# **ASSESSMENT OF HYDROGEN COMBUSTION DURING SEVERE ACCIDENTS IN A NUSCALE PLANT MODULE**

ASSESSMENT OF HYDROGEN COMBUSTION DURING SEVERE  
ACCIDENTS IN A NuScale PLANT MODULE

October 2019

**Work performed under the auspices of  
United States Nuclear Regulatory Commission  
Washington, D.C.  
Under Contract Number NRC-HQ-25-14-E-0002 (Task Order No. 4)**

Figure 3.1.4a Containment atmosphere composition, scenario LCC-05T-03 with 69% oxidation

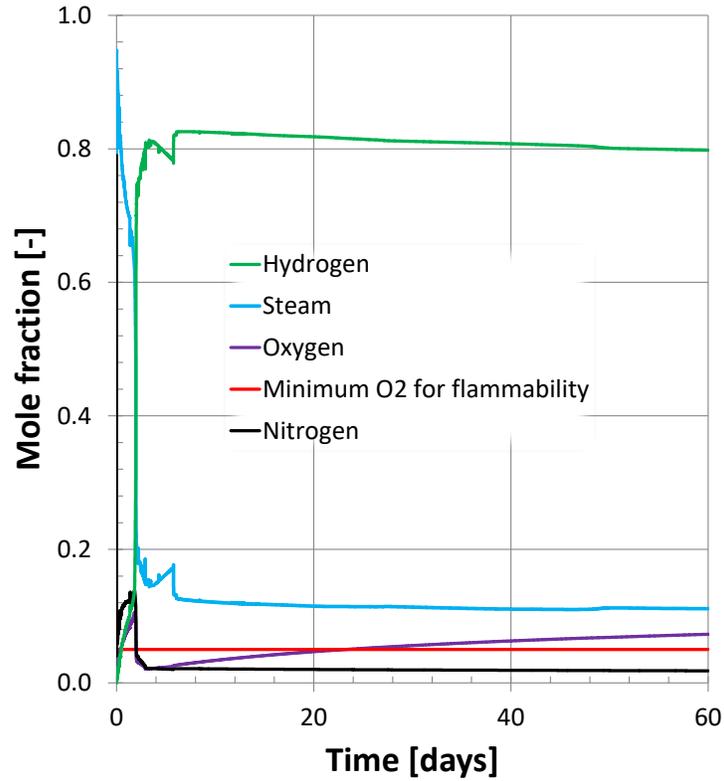
As Figure 3.1.4a shows, the oxygen concentration attains 0.05 at 23 days. Figure 3.1.5 is similar to Figure 3.1.4a but it applies to the case where, by means of a user-defined source, the 64.2 kg of hydrogen generated by the COR package is augmented such that the final oxidation-generated hydrogen is 102.4 kg (110% of 93.3 kg). The oxygen concentration reaches 0.05 at 42 days.

Figure 3.2.4a AICC pressure, AICC temperature, and period of detonability in the case of 69% oxidation

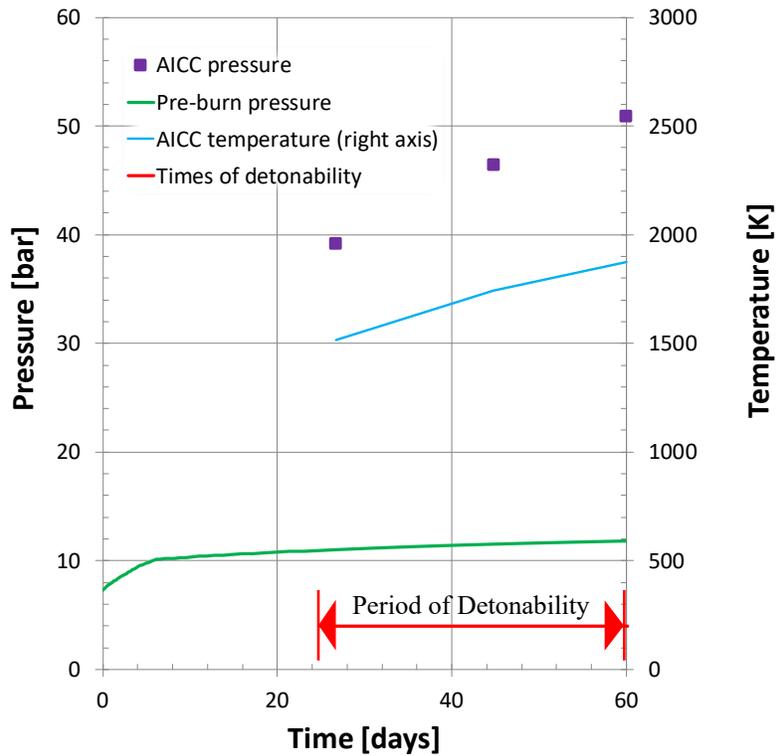
Figure 3.2.4a shows the AICC pressure and AICC temperature for the 69% cladding oxidation case. The flat red curve shows the times when the mixture is detonable<sup>16</sup>. In the present case (69% oxidation), the mixture is detonable at all the times that it is flammable, i.e., from 24 days until the end of the calculation at 60 days. Figure 3.2.4b shows the AICC pressure and the estimated detonation pressure, as fractions of the design pressure. The estimated detonation pressure is just the AICC pressure times  $[[ \quad ]]^2$ <sup>(a),(c)</sup>. The AICC and detonation pressures are shown only at the

time of the onset of flammability (and, in this case, detonability). This is only the earliest time when the combustion becomes possible: it could happen later, in which case the pressures would be higher. The AICC pressure is about  $[[ \quad ]]^2$  (a), (c) the design pressure; the estimated detonation pressure is about  $[[ \quad ]]^2$  (a), (c) times the design pressure, most likely resulting in containment failure. Figure 3.2.4c shows the masses of hydrogen and oxygen.

Figure 3.2.6 Pre-combustion pressure, AICC pressure, and estimated detonation pressure in the case of 110% oxidation, as fractions of the design pressure

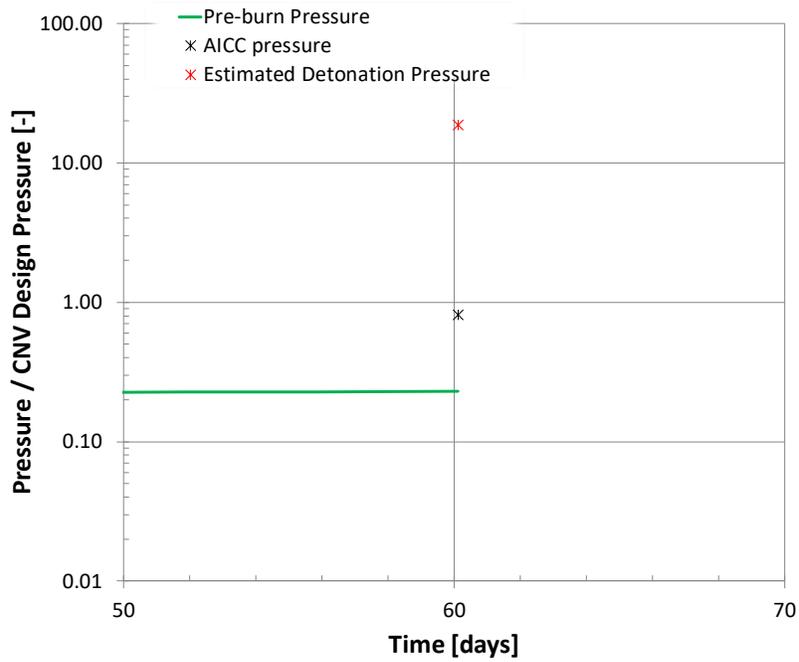
Figure 3.4.6 shows the results for 110% (102.4 kg of in-vessel-produced hydrogen, with 92.7 kg credited to reach containment). Flammability and detonability are simultaneously attained when the oxygen concentration attains 0.05, which happens at 56 days. The AICC pressure at 60 days is 58.8 bar, or 853 psia. The detonation pressure, as estimated by the usual methods, would much exceed the design pressure, 1050 psia. (But recall that the Applicant argues that detonation pressure in excess of the design pressure does not imply vessel failure: Applicant claims that the strain cannot attain the yield strain during the short life of a detonation load.) The Applicant's combustion analysis is based on the AICC pressure of  $[[ \quad ]]^2$  (a), (c) psia as approximately calculated for the mixture that the Applicant predicts for the containment at 3 days (see Section 2.3, and Reference [3]).

Figure 3.2.7 Time required for the oxygen concentration to attain 0.05

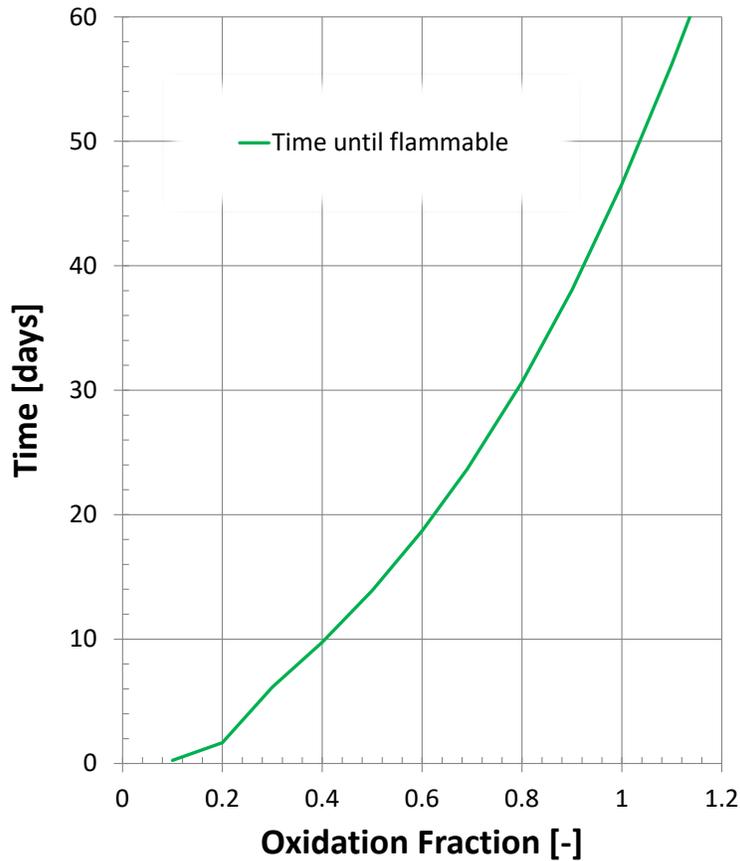
Figure 3.2.7 shows the time required for the oxygen concentration to attain 0.05 as a function of the oxidation fraction. (Recall, this fraction is defined such that the hydrogen mass produced by oxidation is this fraction times 93.3 kg; the calculation has been carried out assuming that 9.4% of the oxidation-generated hydrogen remains held up in the RPV.) As has been discussed, these times may represent the earliest times when operators might take action to restore inert conditions in containment, as a function of the severity of the accident, as quantified by the oxidation fraction. The earliest times (less than 1 day) may correspond to successful but somewhat late ECCS actuation, such that some metal oxidation and fuel damage has occurred, but not so much as to oxygen-deplete the containment for more than a few days. The times for fractions around 50% to 70% (~20 days) might be the best estimates for typical unmitigated severe accidents, since MELCOR typically predicts such fractions in such cases. The 100% value (93.3 kg of in-vessel hydrogen, ~47 days to flammability) could arise in consideration of 10 CFR 50.44 requirements.

In general, it seems that the Applicant's analysis, which is believed to be based on direct calculations similar to those used here, predicts shorter times than those estimated by the present implementation of the direct calculation (Figure 3.2.7). One MELCOR calculation carried out here also gives a shorter time. Thus, the above-quoted results from ERR document ER-P020-4904 include that 104 kg of in-vessel produced hydrogen (or oxidation fraction 1.11 as estimated here) keeps the containment inert for 45 days, quite consistent with MELCOR's prediction of 42 days for fraction 1.10. The estimate by the direct calculation of this report is 56 days for fraction 1.10. As has been discussed, the 42 vs. 56 day discrepancy is largely accounted for by MELCOR's use of its own fraction-dependent prediction of the RPV hydrogen hold-up fraction, which in the 110 % case reduces the hydrogen in the containment in MELCOR, relative to the direct calculation. The direct method uses the same hold-up fraction for all oxidation fractions. As has

Accidents attaining core damage will ordinarily entail oxidation of a sizable fraction of the cladding (e.g., more than 20%). The hydrogen generated thereby results in a containment atmosphere that is too rich to support combustion until the slow process of radiolysis adds enough oxygen to restore the molar concentration (of oxygen) to more than 5%. For example, if 30% of the cladding oxidizes, the present study estimates that the containment atmosphere remains not flammable for about 6 days (see Figure 3.2.7). On such long-time scales, the particular progressions of different severe accident scenarios would not be of any significance with little to distinguish them except the oxidation fraction. Therefore, Figure 3.2.7 has wide applicability, even though it is partly based in a particular scenario (very small CVCS line break with no ECCS actuation, and with imposed cessation of core oxidation at the variously considered fractions). This study finds that, with rare exceptions, the containment is detonable if it is flammable. Although the Applicant argues that the containment can withstand detonation pressures as high as  $\sim [[ \quad ]]^{2(a),(c)}$  times the design pressure (i.e.,  $[[ \quad ]]^{2(a),(c)}$  bar /  $[[ \quad ]]^{2(a),(c)}$ ), prudence probably dictates that a goal post-accident actions would be to prevent detonability. This implies keeping the oxygen concentration below 5%, for which goal Figure 3.2.7 implies the following:
